DART AEROSPACE LTD	Work Order:	22961
Description: Support Assembly	Part Number:	D3278-041
Dwg: D3278 Rev. A	Qty:	80 79
		Page 1 of 2

DESIGN CP	DRAWN BY CP	DART AEROSPACE LTD HAWKESBURY, ONTARIO, CANADA	
CHECKED [Signature]	APPROVED [Signature]	DRAWING NO. D3278	REV. A SHEET 1 OF 3
DATE 04.03.03		TITLE SUPPORT ASSEMBLY	SCALE NTS
A	04.03.03	NEW ISSUE

D3278-041 SUPPORT ASSEMBLY

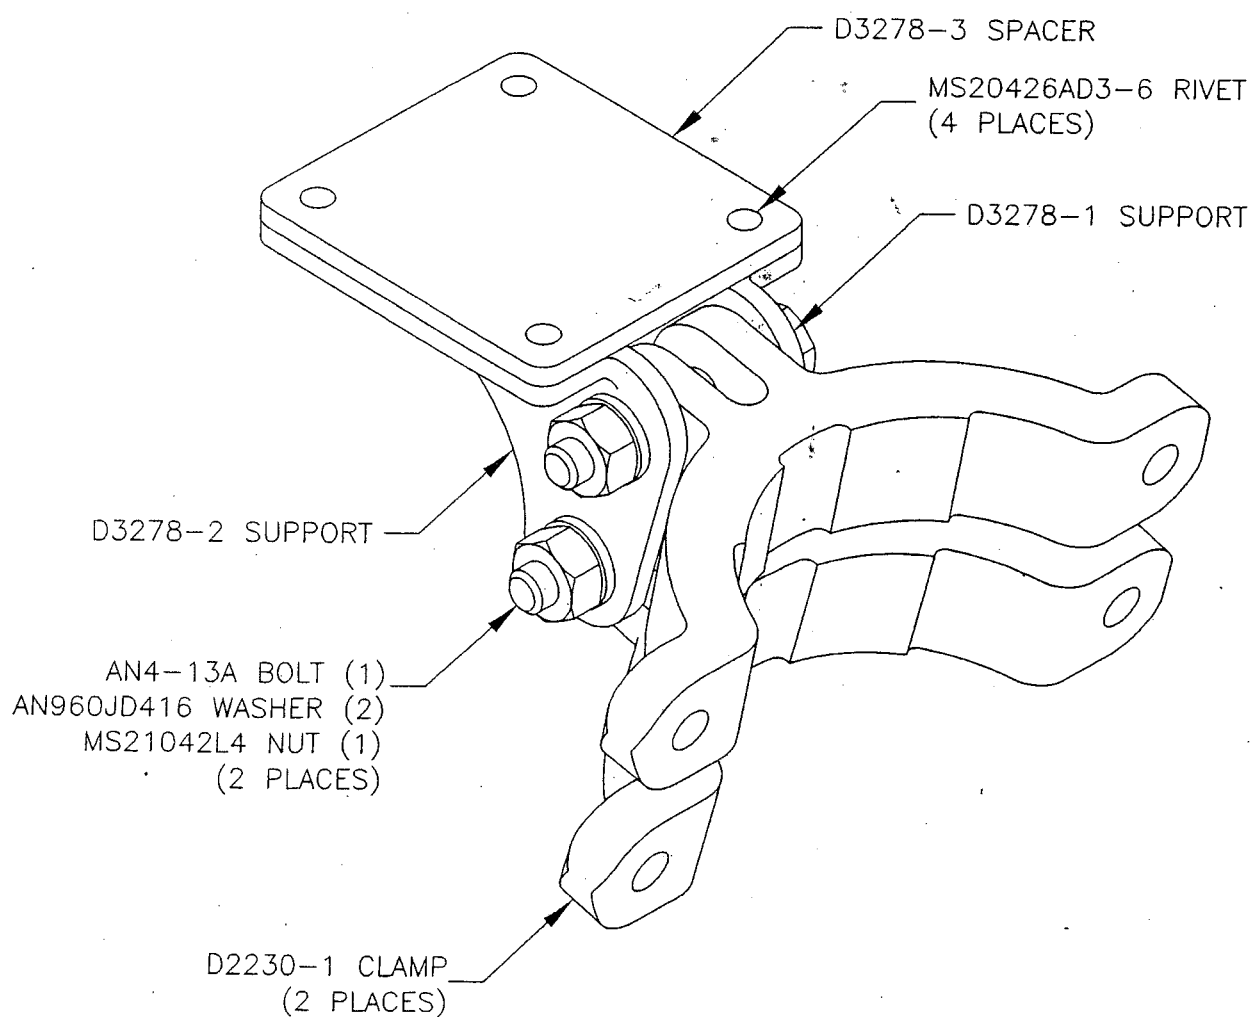
W/O:		WORK ORDER CHANGES					
DATE	STEP	PROCEDURE CHANGE	By	Date	Qty	Approval Mfg / Design Mgr	Approval QC Inspector
05-05-18	16	MS20426A03-6 rivet to short, change rivet to MS20426A03-7 (No -7 in stock LL. put them on order) Permanent Change		05-06-09	N/A	 05.05.18 per 05142	 05-05-18

W/O:		WORK ORDER CHANGES					
DATE	STEP	PROCEDURE CHANGE	By	Date	Qty	Approval Mfg / Design Mgr	Approval QC Inspector
05.05.18	18	DO NOT TIGHTEN AN4-13A BOLTS. LEAVE LOOSE TO ALLOW CUSTOMER TO ADJUST FIT ON XTUBE <i>Permanent Change</i>	<i>[Signature]</i>	05-06-07	N/A	<i>CP</i> 05.05.18 per QSI 692	<i>2</i> 05-05-18

The compressed head of the rivet should be about 0.046" (1/2D of 3/32 rivet), but can be as small as 0.020" for many.

I think this should have been caught after a few rivets, but I think the parts are acceptable as is.

For the future I will tell Dan he can use longer rivets as needed to get the proper head, and he can approve it based on qsi 042.
